RESOLUTION NO. 1152

RESOLUTION ADOPTING THE PLANNING COMMISSION RECOMMENDATIONS TO AFFIRM AND ADOPT THE PLANNING COMMISSION'S INTERPRETATION, FINDINGS AND CONDITIONS REGARDING PRIMARY OPEN SPACE LOCATED ON TAX LOT 1903, T3S-R1W, SECTION 11, MR. JACK MARTIN, APPLICANT.

**REQUEST: 94PC41 - Review Stage II, Phase II, Site
Development Plans for a warehouse distribution
building (Building B).**

SITE PLAN

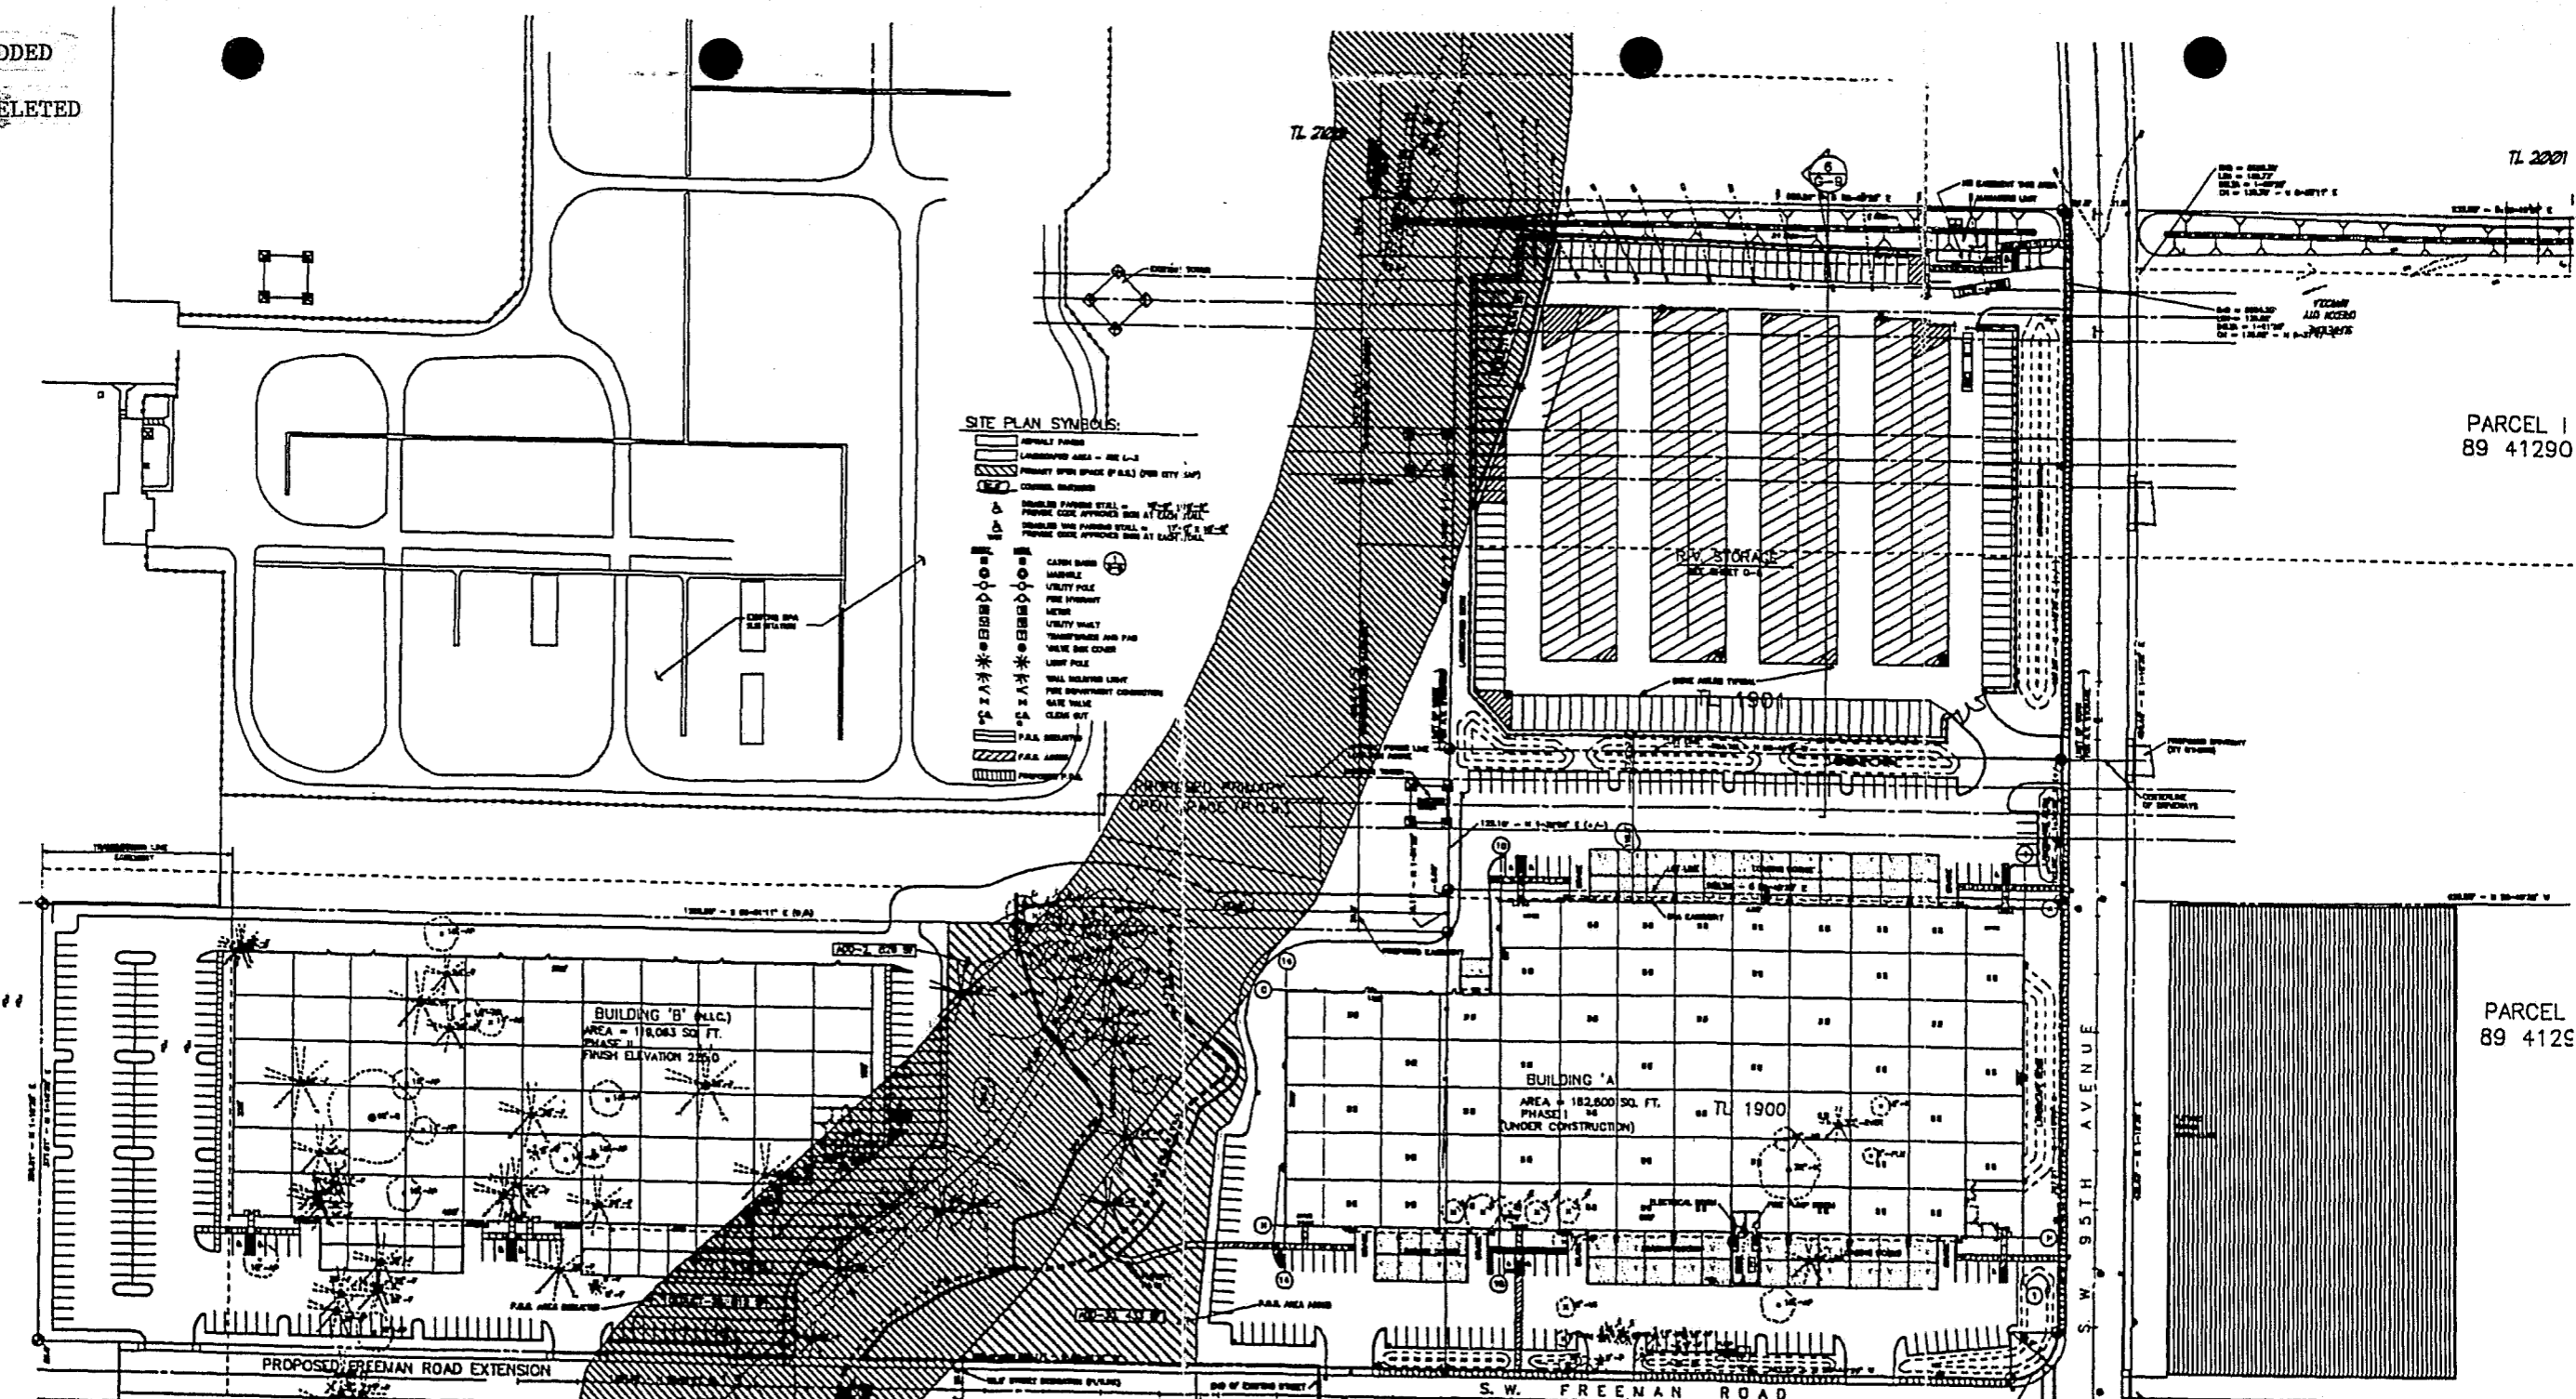
This letter addresses the issue of the redefinition of the primary open space that passes through the Martin parcel. The map identifying the primary open space in the comprehensive plan was at a very large scale, and in this area does not appear to have properly identified the property that meets the primary open space criteria. The areas proposed to be removed from the mapped POS meet none of the stated criteria (see Staff Report). It appears that the intent was include the location of Basalt Creek. Criteria no. 4 for POS is "major natural drainage channels". Our proposal is to move the POS to where Basalt Creek is actually located.

The areas proposed to be added to the POS include two much larger fir trees and Basalt Creek. It is proposed to add considerable landscaping (see plans).

The Planning Commission recommends approval of Stage II site development plans for Phase II (building B), with Conditions of Approval attached herein. Modify the extents of the Primary Open Space shown on the Comprehensive Plan Map to reflect the revised POS boundary on the developer's site development plan.
